UNITED STATES PATENT AND TRADEMARK OFFICE

APPLICATION NO.	FILING DATE	FIRST NAMED INVENTOR	ATTORNEY DOCKET NO.	CONFIRMATION NO.
09/935,337	08/23/2001	Karl-Heinz Krah	41110	8132

Office Action Summary

DETAILED ACTION

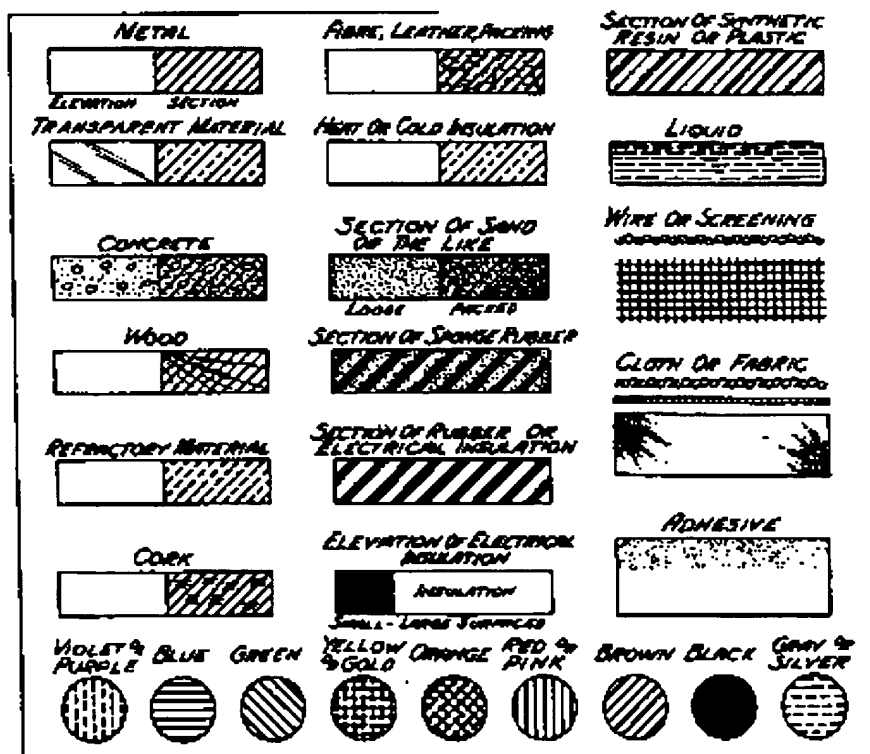
The drawings are objected to because of the following informalities:

Fig. 1-3, 5-8, 10-16: Proper cross-sectional hatching is required to properly denote plastic materials in accordance with MPEP 608.02 (see the drawing below for proper hatching examples).

The response to this action must include a separate letter addressed to the examiner and contain: (1) sketches showing in red the drawing changes required above and (2) a request that the examiner approve the changes as shown on the sketches.
